Ramon John Bambach

Office Action Summary	Application No. 10/512,003	Applicant(s) BAMBACH, RAMON JOHN	
	Examiner BENJAMIN P. LEE	Art Unit 3641

DETAILED ACTION

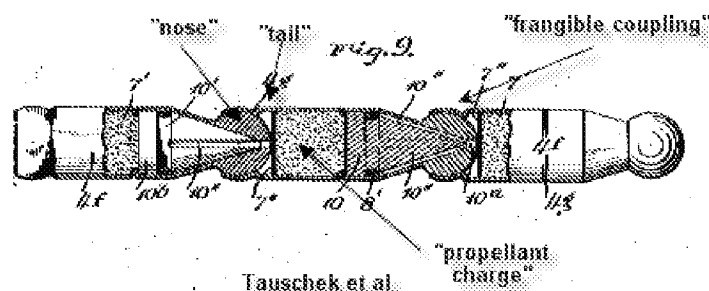
6. In regards to claims 22 and 41, TAUSCHEK et al disclose a projectile sealing arrangement including at least two projectiles coupled together by a frangible coupling (see TAUSCHEK et al fig. 9 following) to form a chain wherein each projectile has a head portion, tail portion and a respective propellant charge (see TAUSCHEK et al fig. 9 following), and wherein the frangible coupling includes a first retaining means disposed on the tail portion of the leading projectile engaged by a screw action with a second retaining means disposed on the head portion of the trailing projectile. Note that TAUSCHEK et al teach projectiles with a head portion that inserts into a tail portion of a proceeding projectile and that the projectiles retaining means are capable of engagement by a "screw action" (twisting one projectile into the other).

7. In regards to claim 26, TAUSCHEK et al disclose that the seal includes contact between complementary surfaces on the leading and trailing projectiles (see TAUSCHEK et al fig. 9 following).

8. In regards to claims 27, 30 and 42, TAUSCHEK et al disclose that the first and second retaining means includes complementary spigot and socket on the trailing and leading edges respectively (see TAUSCHEK et al fig. 9 following). Note that TAUSCHEK et al disclose a ball and socket retaining means which constitutes complementary spigot and socket as claimed.

9. In regards to claims 31 and 43, disclose that either the first or second retaining means is frangible (see TAUSCHEK et al fig. 9 following). Note that the “ball” and “socket” disclosed by TAUSCHEK et al in figure 9 constitutes a “frangible coupling” since they separate or “break”).
